TO: AUTHORIZED *Portable Electric Tool* SERVICE STATIONS
factory SERVICE CENTERS
SALES COMPANIES

DATE: June, 2001

TOOL(S) \ PRODUCT(S) AFFECTED

SUBJECT: 31-17-0265 Cord Clamp - Cord Field Lead wire connector disconnected

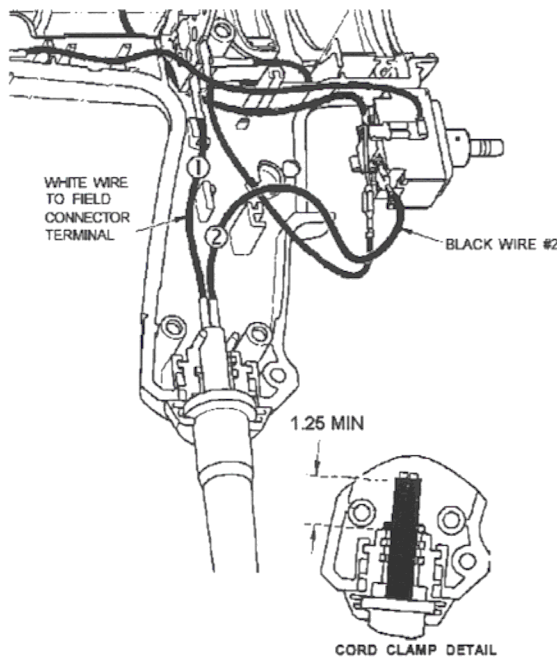
To improve cord retention in 9070-20, 9071-20, 9075-20 1/2" Impact Wrench original equipment 31-17-0265 Cord Clamp is being replaced by 31-17-0270 Cord Clamp.

Clamping rib of the 31-17-0270 Cord Clamp is slightly larger and offers improved holding of the cord in the handle.

As an aid in determining the cord clamp in a tool, the 31-17-0270 Cord Clamp has the numbers '0270' molded into the clamping rib. The 31-17-0265 Cord Clamp has no markings on the rib.

Wiring specification has been modified increasing the length of cord inserted through the strain relief, cord clamp and into the handle from .25" pass top of cord clamp to 1.25" [see illustration].

All 9070-20 below serial number **229A4012540722**, 9071-20 below serial number **230A401260104** and 9075-20 below serial number **239A401250404** received for repair should have a 31-17-0270 Cord Clamp installed.
